November 20, 2003  
5928-03-20234

Three Mile Island, Unit 1  
Operating License No. DPR-50  
NRC Docket No. 50-289

Subject: Additional Information Concerning a Proposed Alternative Associated with the  
Use of a Weld Overlay

**ATTACHMENT 1**  
**RESPONSE TO ADDITIONAL QUESTIONS**

**SR0010BM Weld Overlay  
Proposed Scan Coverages & Plots based on Design Input  
TMI**

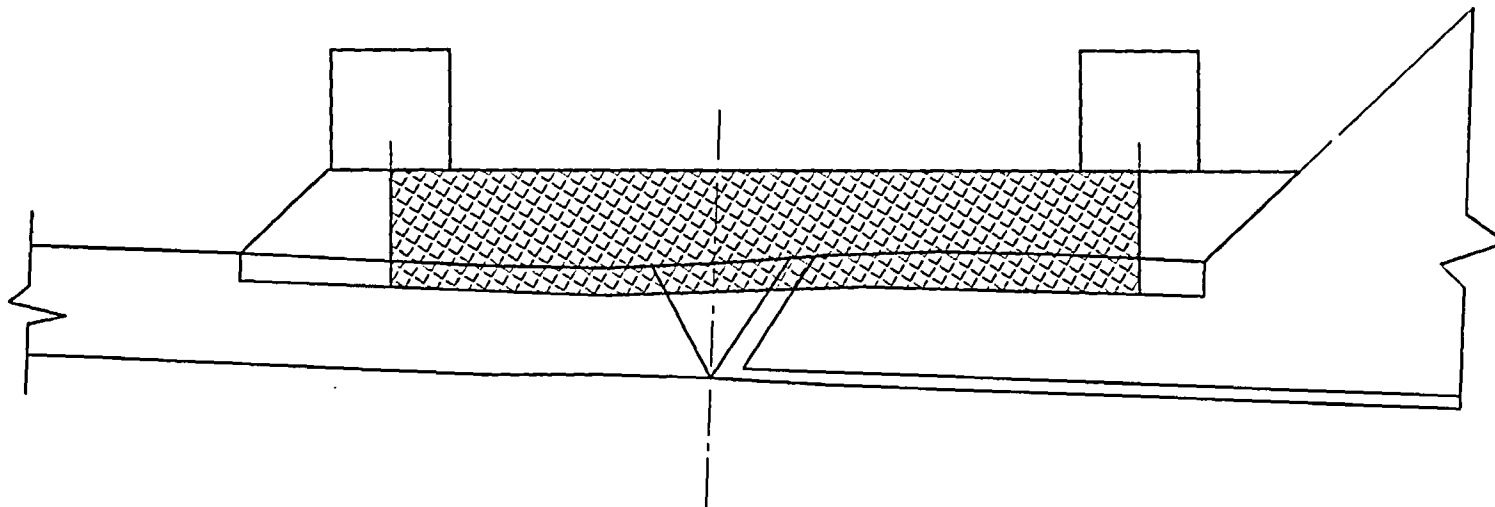
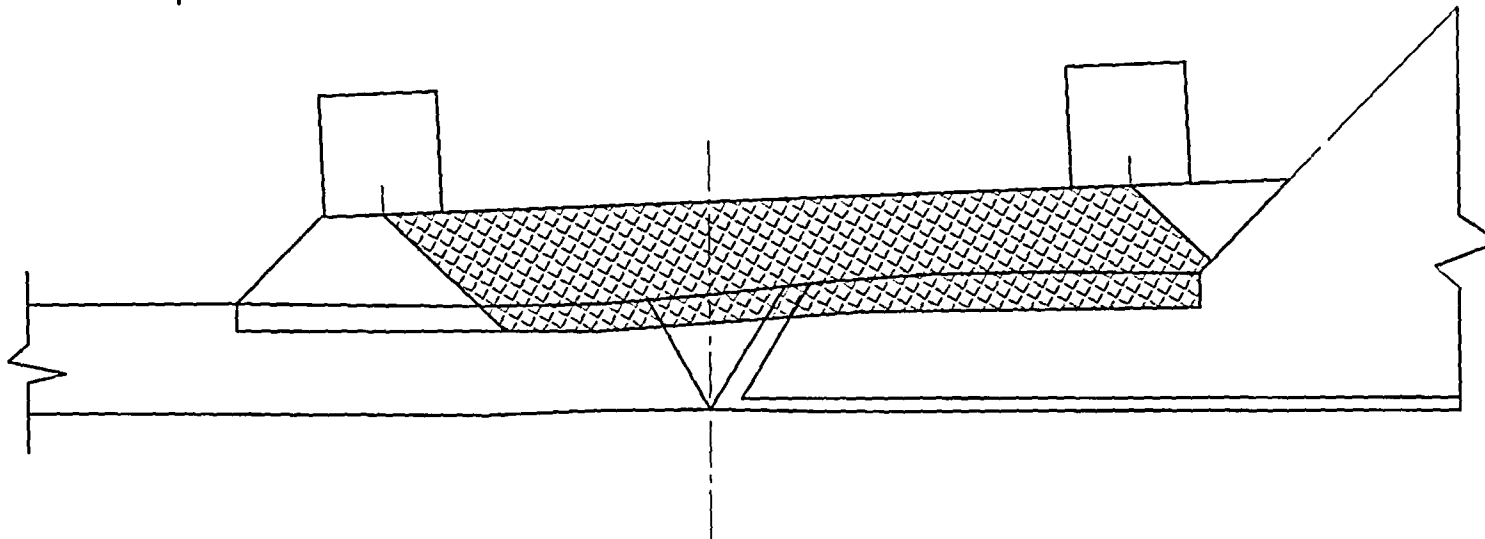
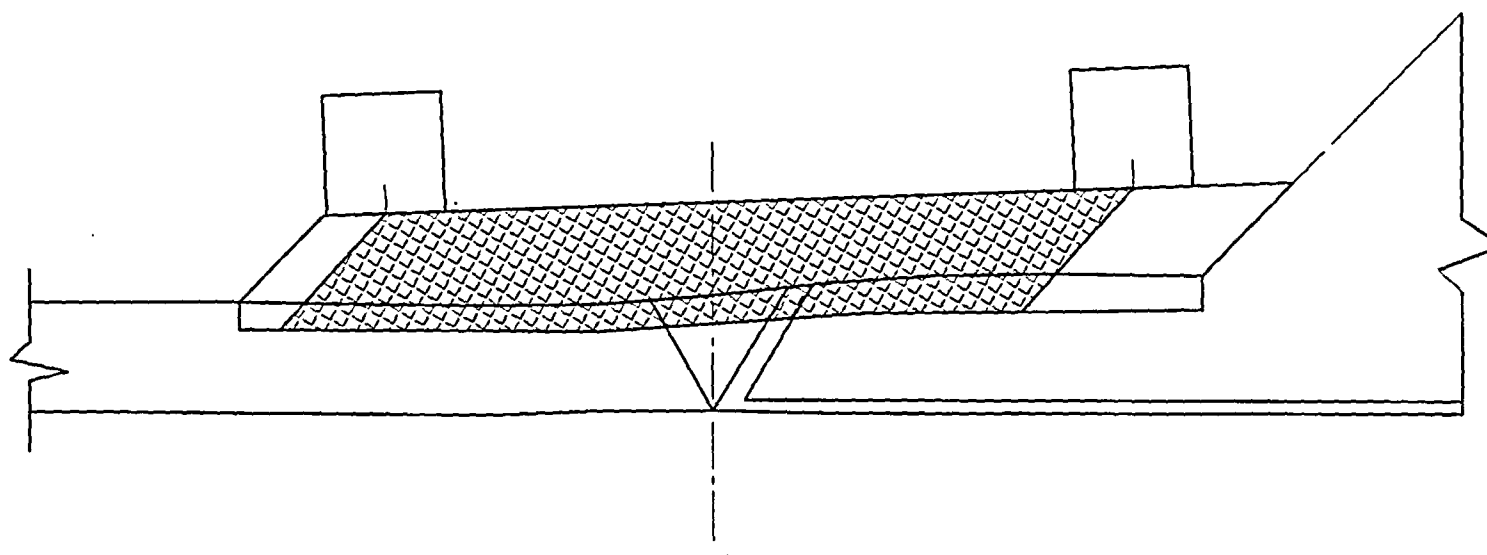
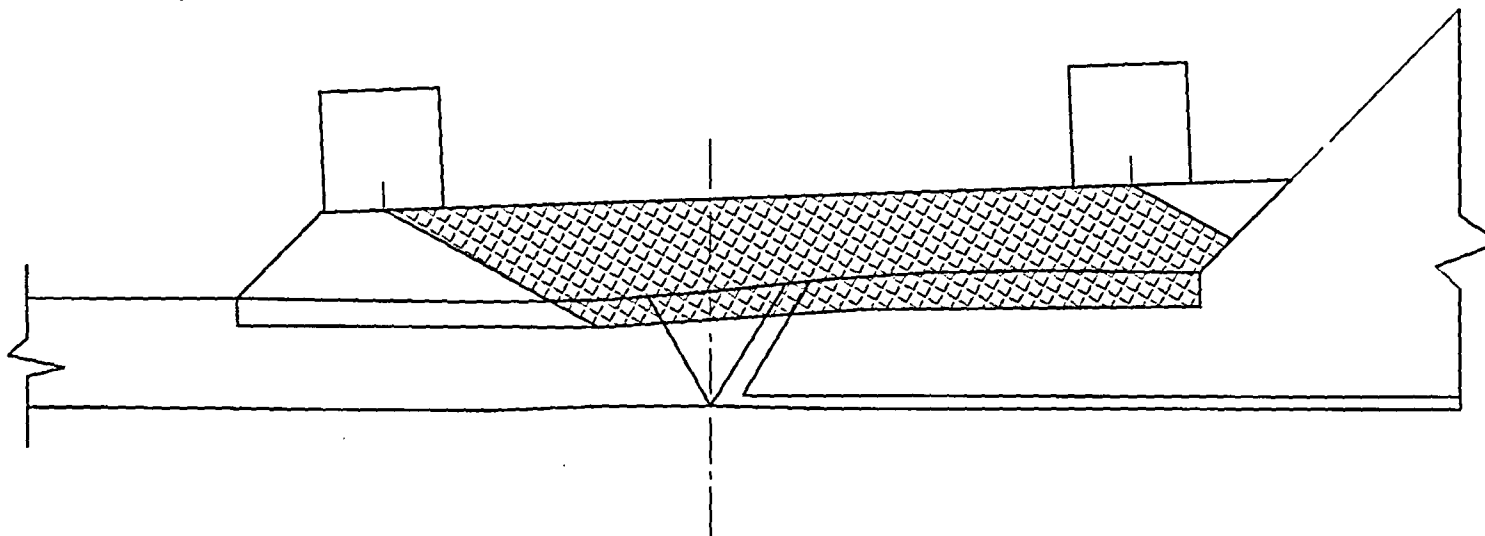
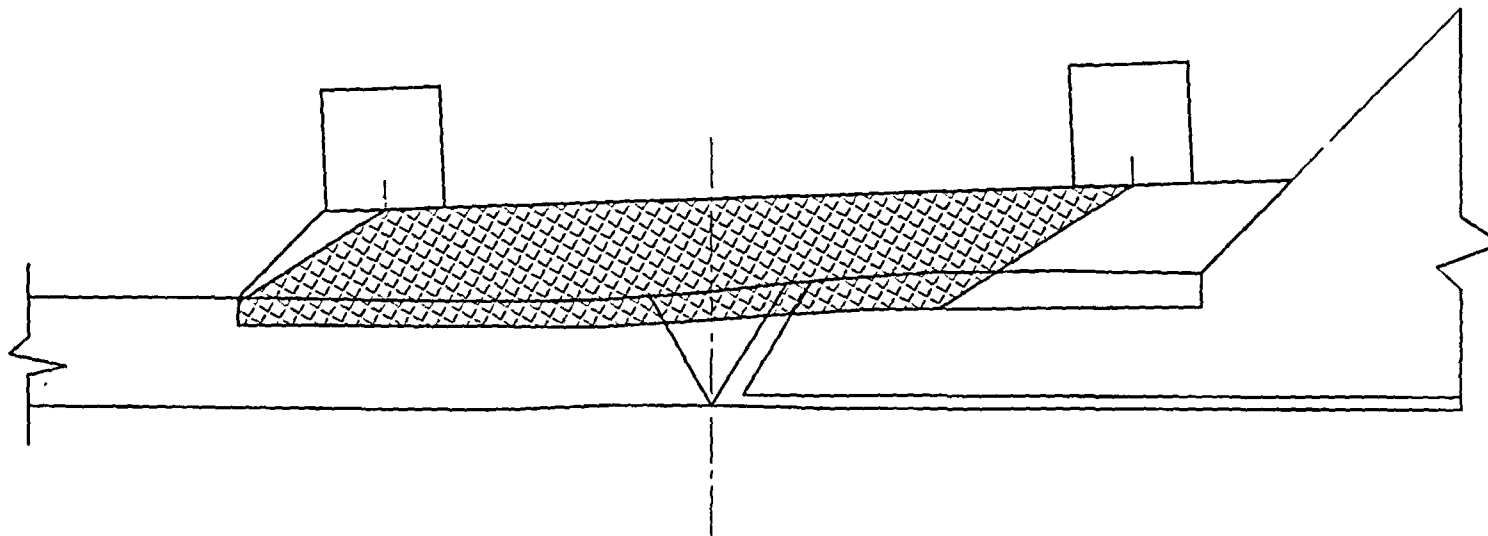
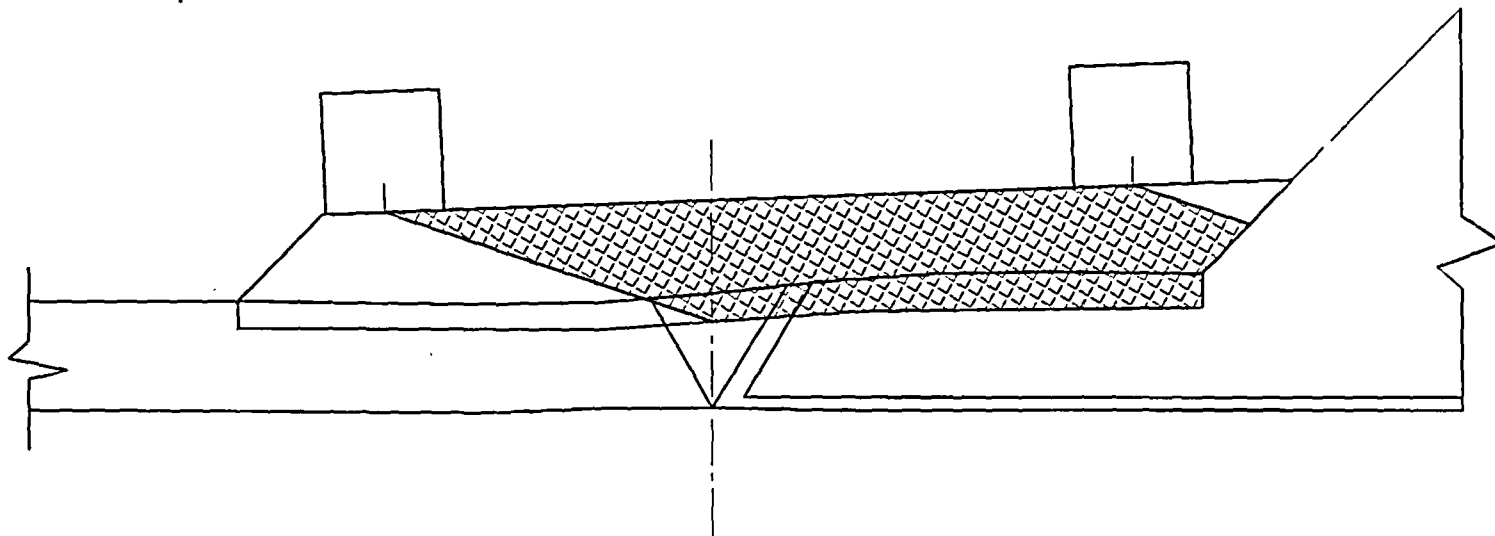
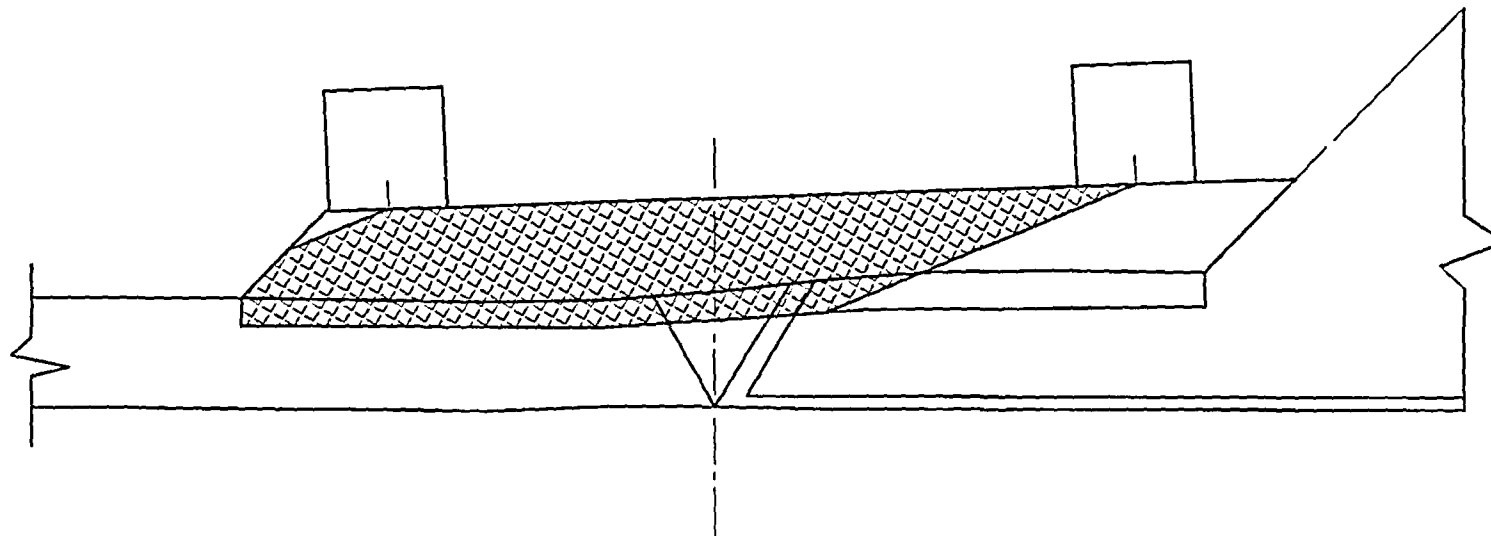
2.0 In the November 3 submittal, Table 3 states that the examination volume will be the volume examined in the PDI demonstration. Provide a sketch showing cross-section with dimensions of the PDI inspection volume. Will the inspections include the ferritic base metal beneath the overlay? If not, explain why this area is not susceptible to crack growth?

For the preservice inspection as noted in Table 2 of the Reference 1 submittal, the entire length for the full circumference of the overlay will be examined. The outer 25% of the original pipe wall will also be examined to the maximum degree allowable by the weld overlay configuration. An estimated coverage map is provided in Attachment 1.

Future inspections will be covered as discussed in Table 3 including ½ inch on either side of the original weld. Inspection on either side of the original weld will find any postulated flaw extending into the stainless steel or carbon steel. The carbon steel is not expected to have any active degradation; therefore, interrogation of the ½ inch on either side of the original weld is conservative. This is based on past IGSCC experience in BWRs.

**SCHEMATIC SHOWING BASIS FOR DETERMINATION OF WELD  
OVERLAY THICKNESS**

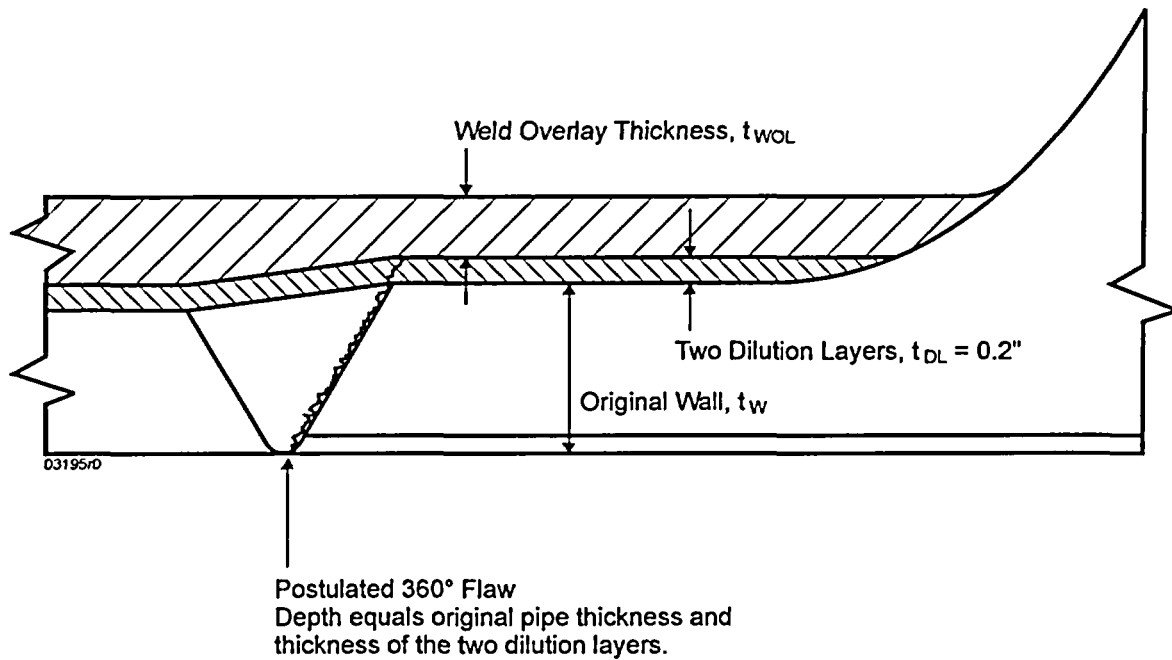
3.0 In the November 3 submittal, Table 3 states that the acceptance standards for the volumetric examination is that "No planar flaw extending into the structural weld overlay." In the November 7 submittal, the answer to question 3.0 states that Code required no flaw greater than 75% of the wall. In the sketch for question 2.0 above, (or separate sketch of the overlay and butt weld cross section) show the maximum height of the embedded flaw that would be within the Code acceptance.

The overlay replaces the pressure boundary as discussed in our response to question 3b of the Reference 2 submittal. The maximum extent of cracking can go through the original pipe wall and through the first two diluted layers of the overlay; this material is not considered or credited as part of the new pressure boundary (see Attachment 3, "Schematic Showing Basis for Determination of Weld Overlay Thickness"). There can be no crack penetration into the structural portion of the overlay. The weld overlay re-establishes the 75% criteria established by the Code. The November 7 response to Question 3.0 relates to the design of the overlay thickness based upon the ASME Section XI requirement that limits maximum flaw depth to 75% through-wall. The weld

overlay repair was designed to meet this code requirement assuming the flaw depth extended through the original wall thickness plus the first two (2) diluted layers of weld overlay material.
